Planning Commission Staff Report

Meeting Date: May 09, 2024

Petition: **P.Z. 02-2024 18009 and 18045 N. Outer 40 Rd. (Gumbo Flats Properties, LLC)**: A request for an ordinance amendment to create a new “PI” Planned Industrial District for two parcels zoned “M3” Planned Industrial District, “NU” Non-Urban District and “PI” Planned Industrial District, and totaling 78.07 acres located on the north side of Outer 40 Road (16W310045 and 16W240041)

Figure 9: Tree Stand Delineation

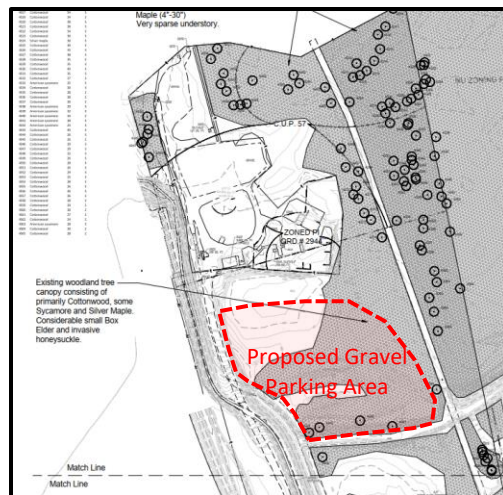
Concern was raised regarding the amount of tree removal associated with the proposed improvements. Please provide information on how the development team will be addressing this concern.

Response: Tree removal is limited, 11.6% being removed and 88.4% retained of the overall Gumbo Flats Property LLC. Assemblage.

DRAWN BY:	CHECKED BY:
A.C.D.	G.M.S.
DATE:	JOB NO.:
01/26/2024	222-7282.1
REG. P.#	RSE MAP #
SLC. MAT.#	16W & 17W
M.D.N.R.#	MAT. SUP.#
SHEET TITLE:	
	OVERALL SITE PLAN
SHEET NO.:	PDP 1.0

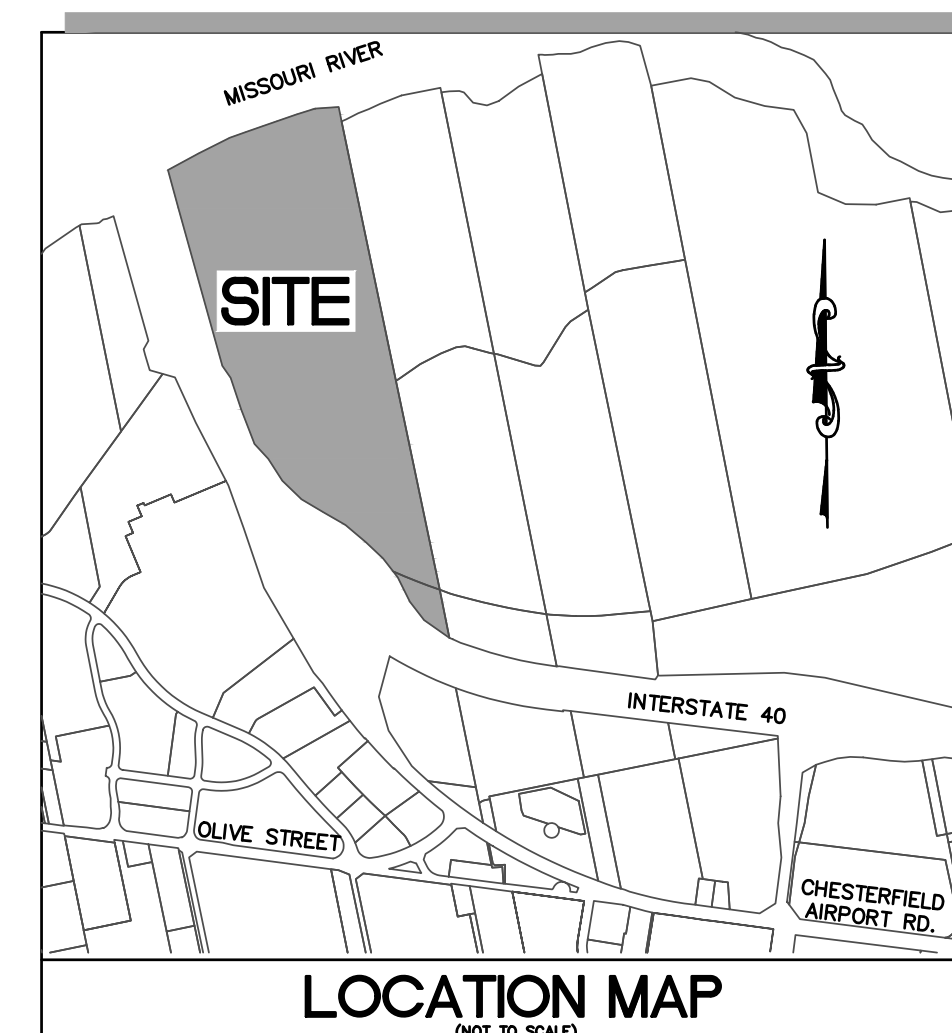
9. Please clearly depict the limits of all flood zones and supplemental protection area in the plan.

Response: Added to the plan.

Sheet Title:	Tree Stand Delineation North
Sheet No.:	TSD-1
Date:	1/25/24
Job #:	813.026

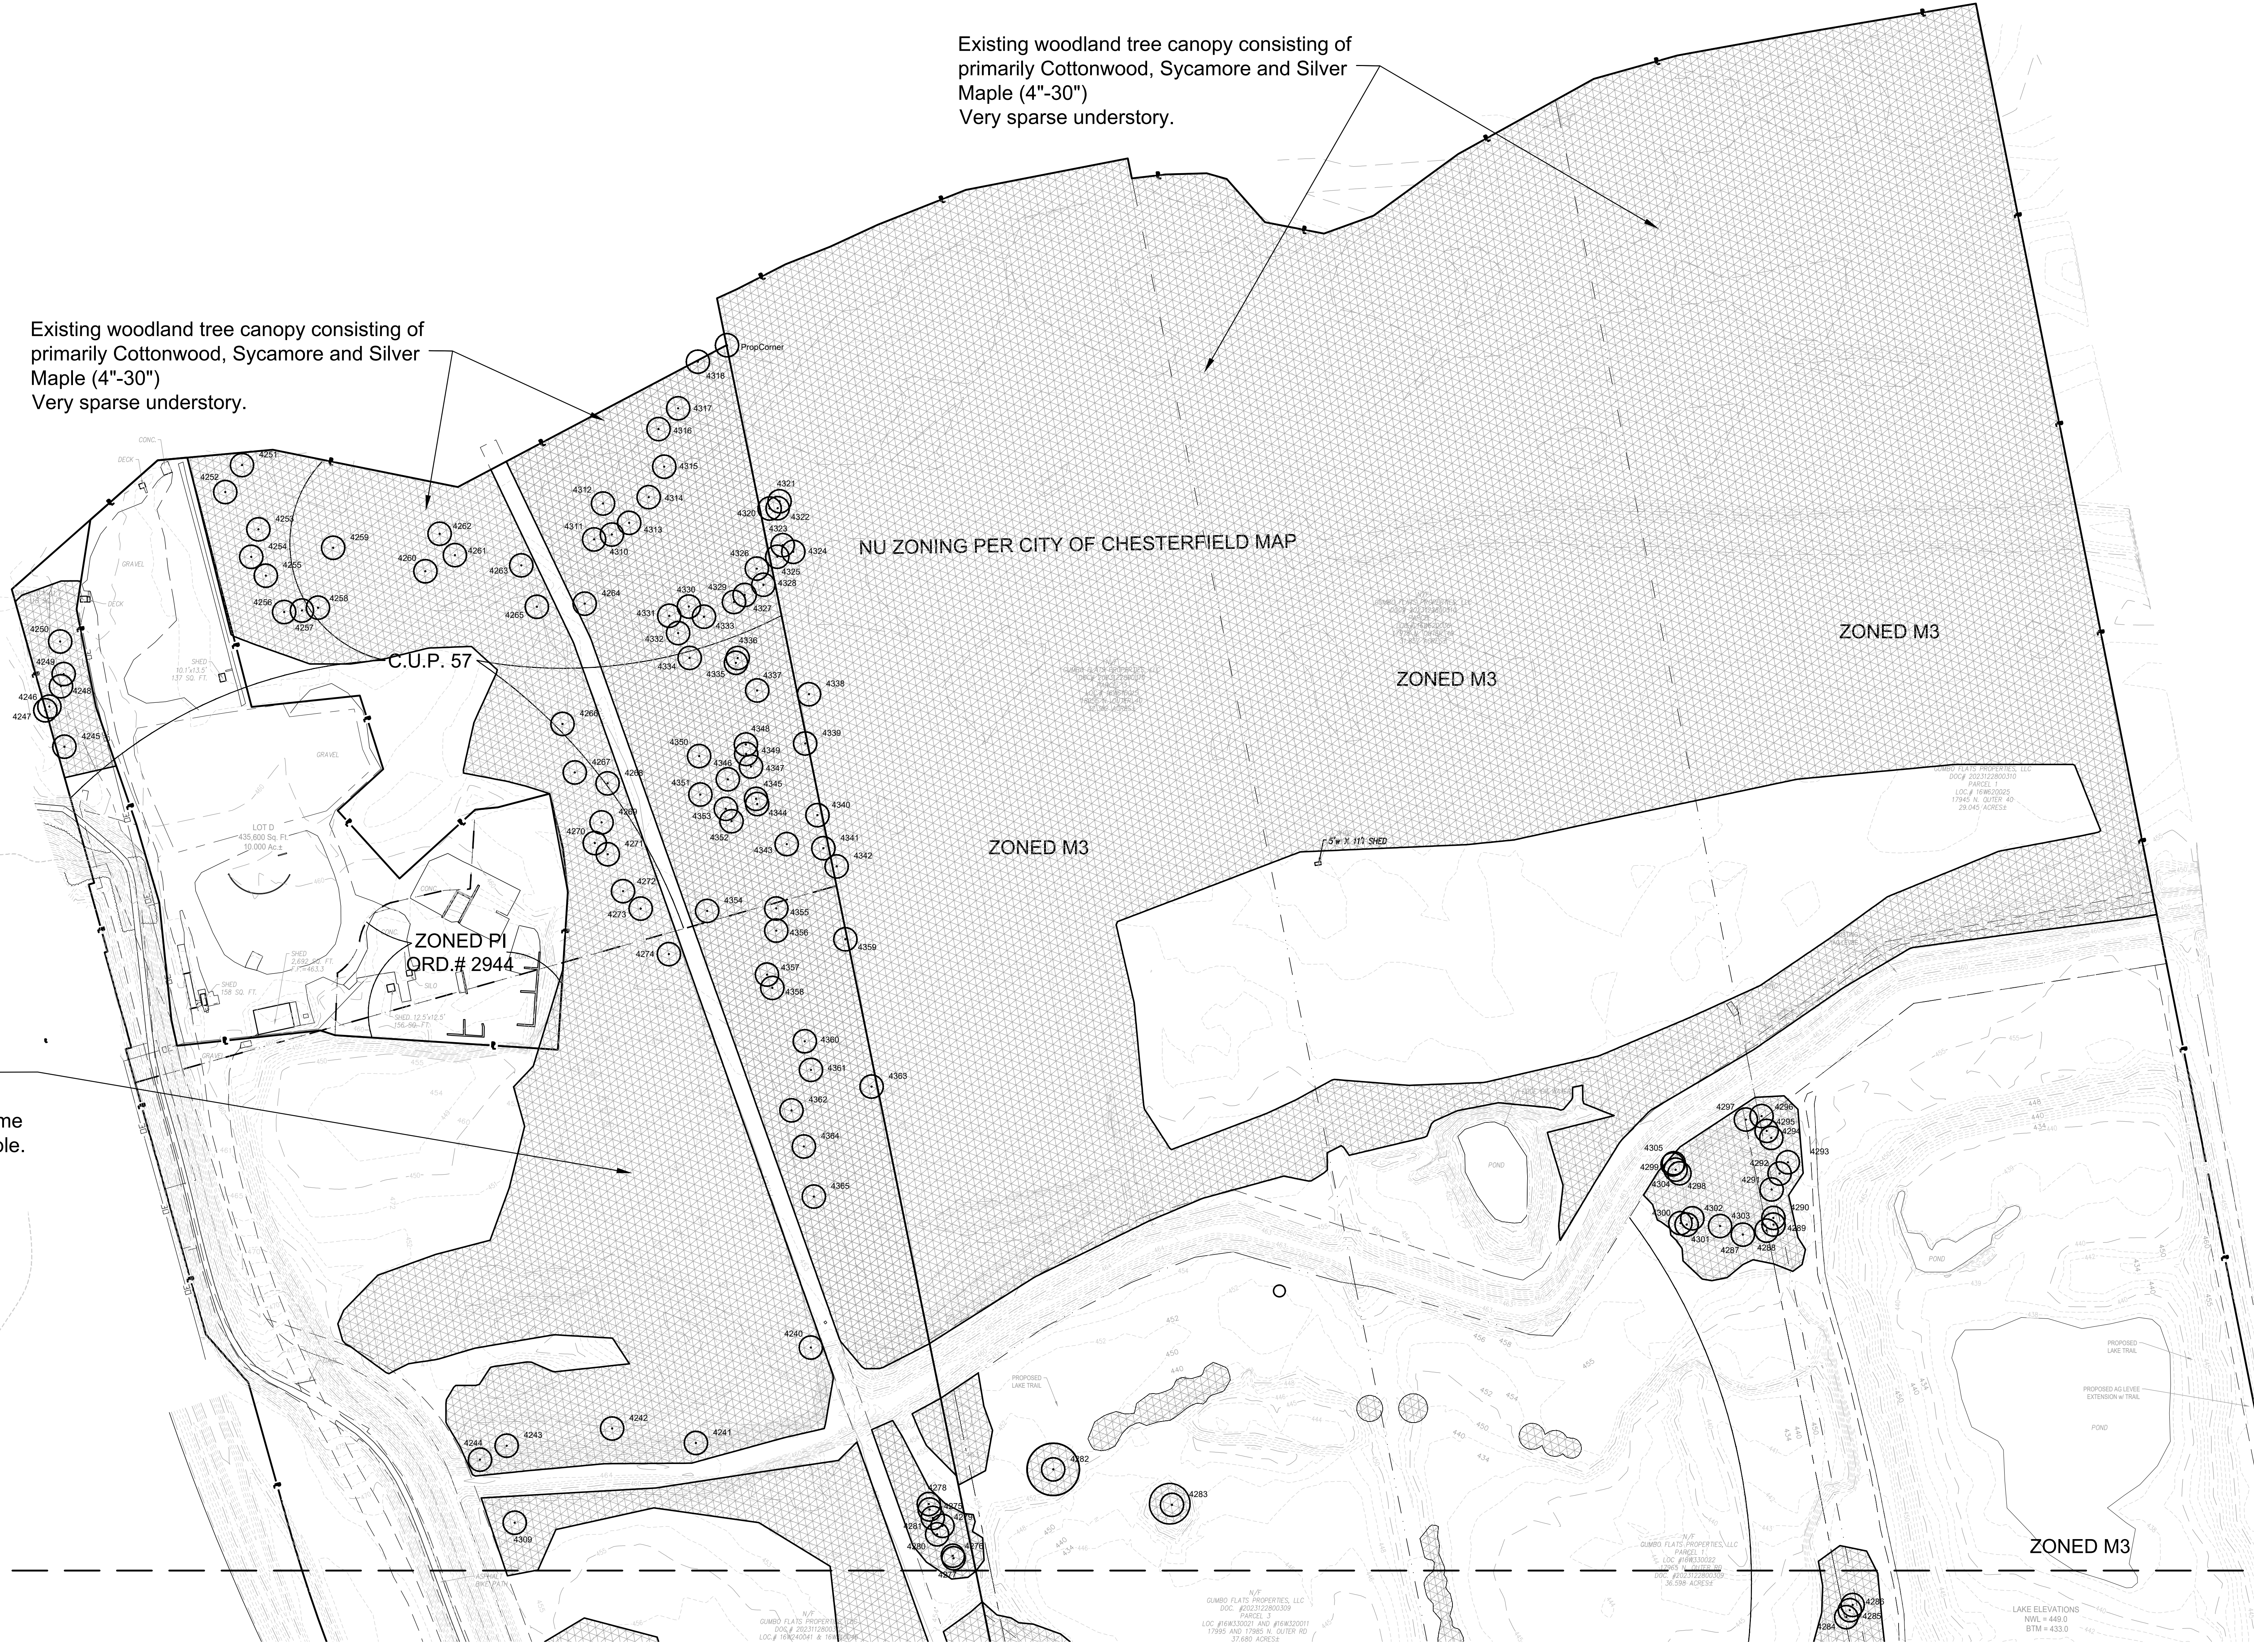
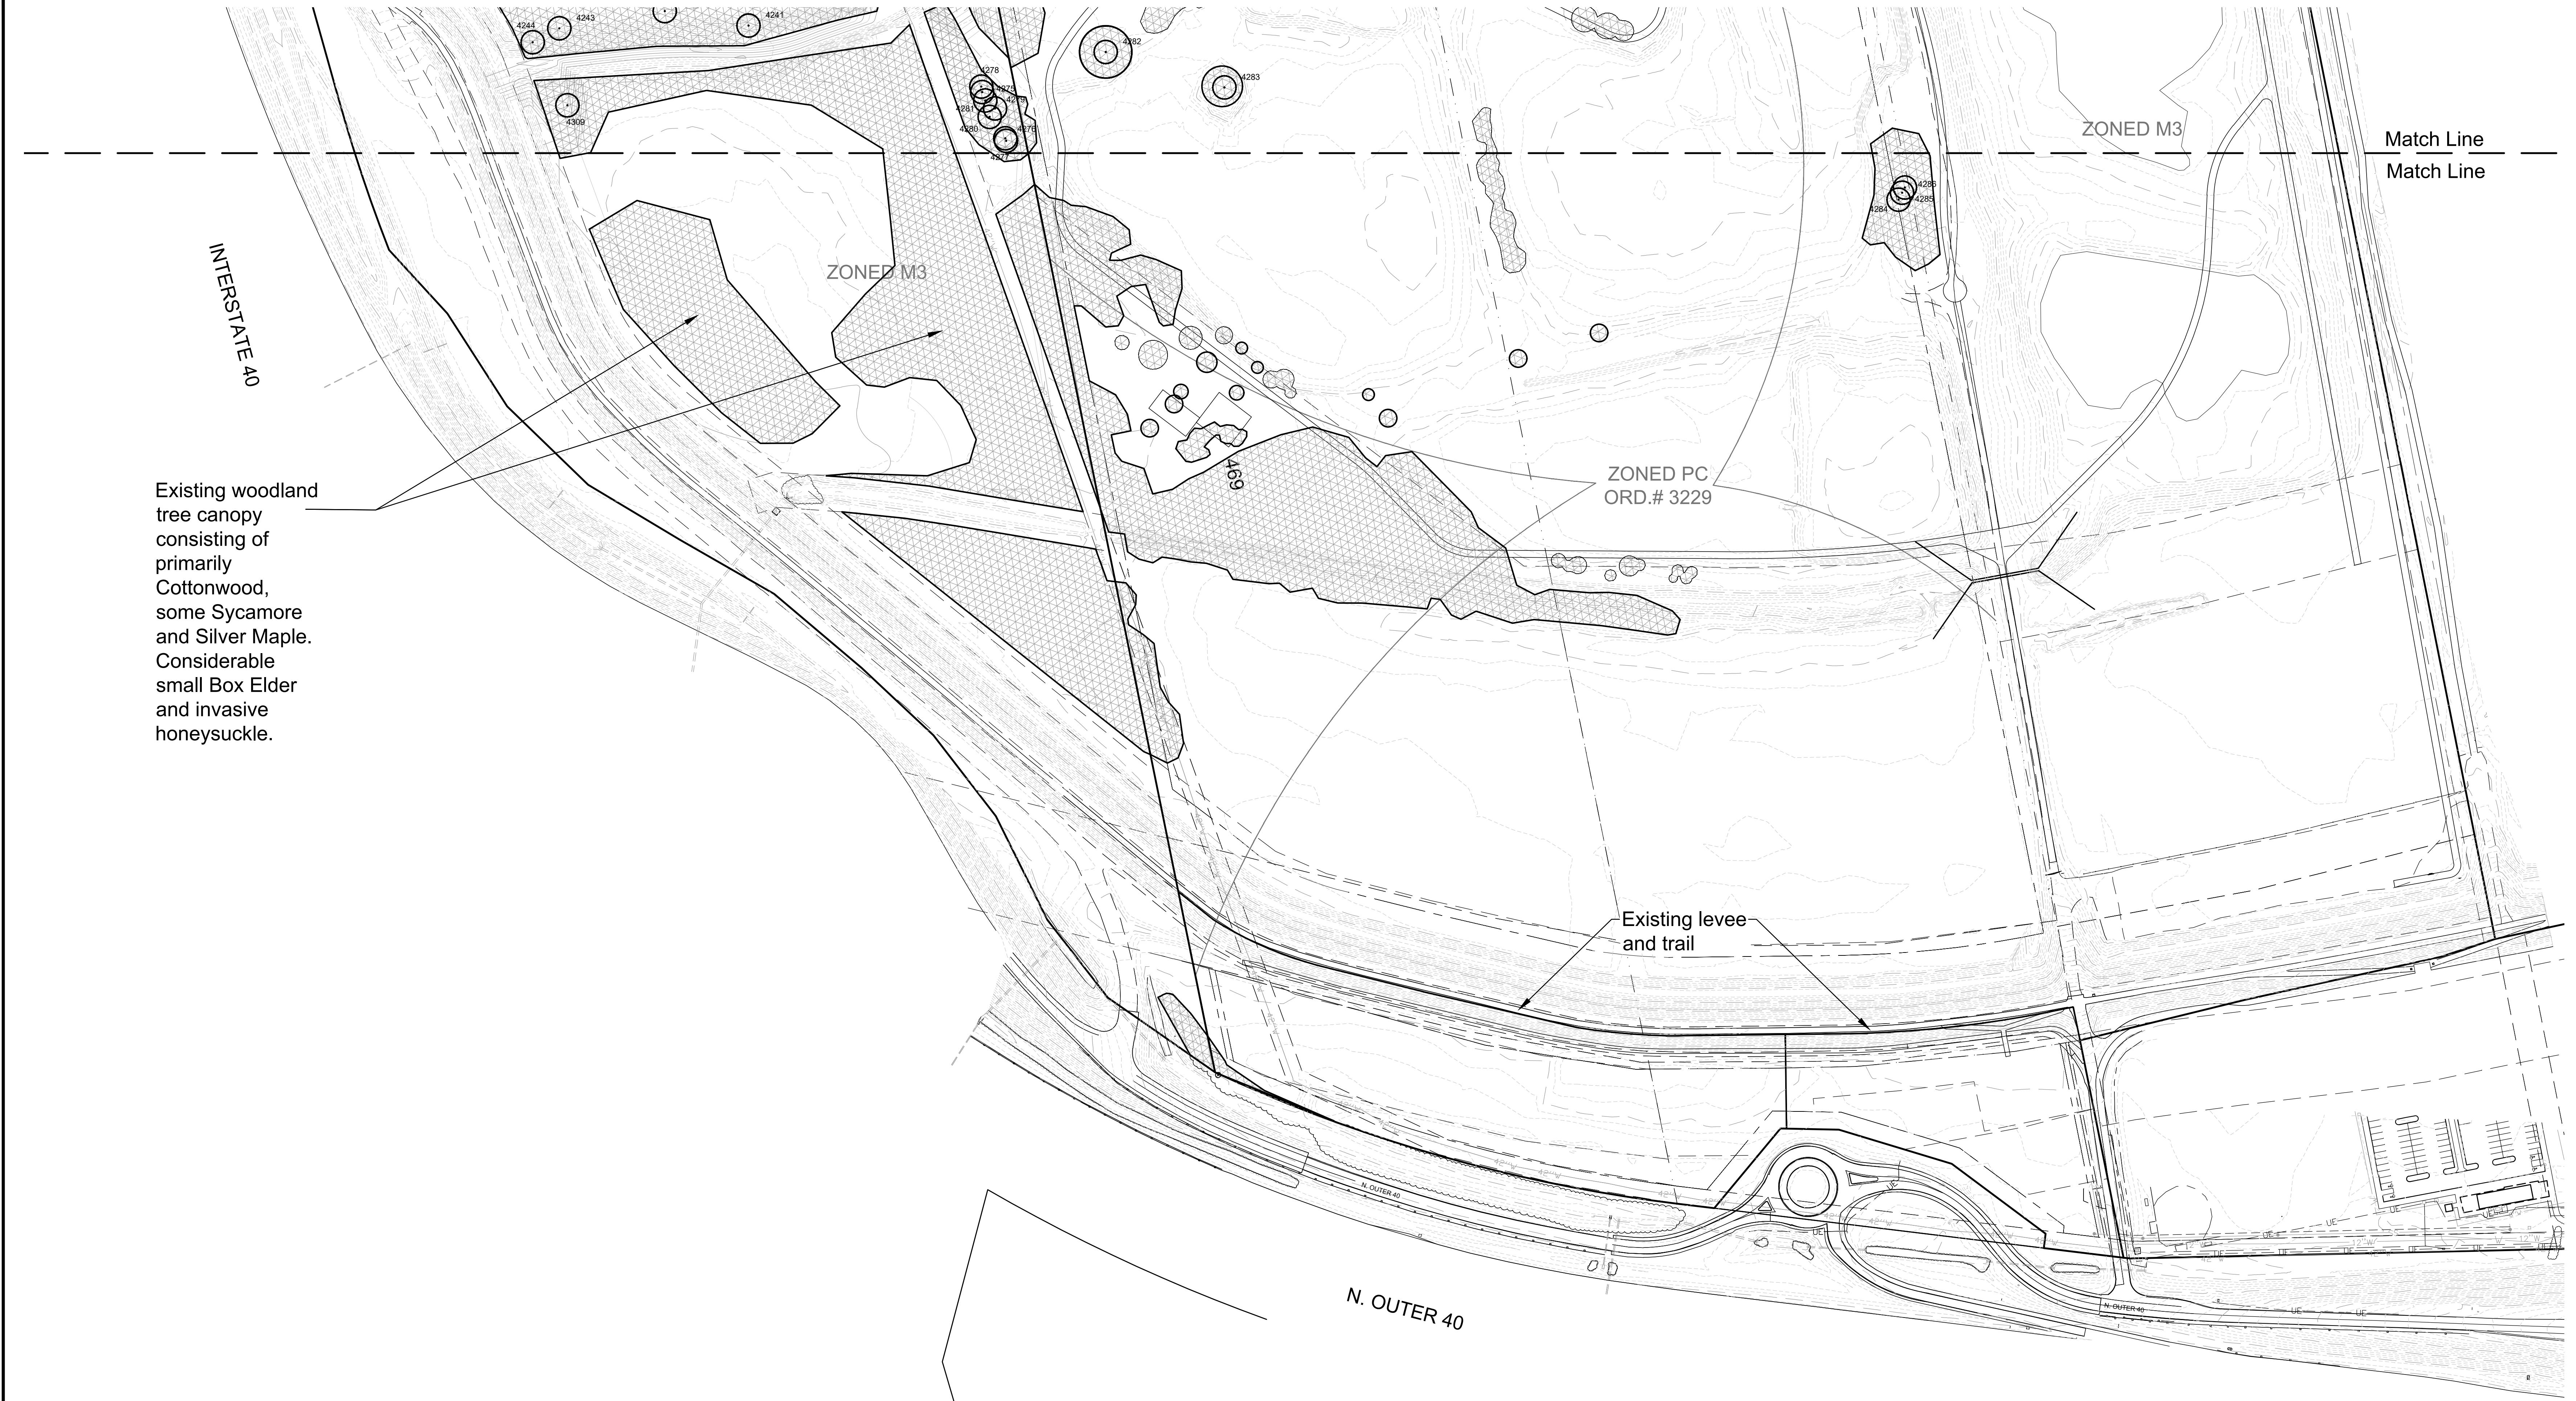
2. Concern was raised regarding the amount of tree removal associated with the proposed improvements. Please provide information on how the development team will be addressing this concern.

Response: Tree removal is limited, 11.6% being removed and 88.4% retained of the overall Gumbo Flats Property LLC. Assemblage.
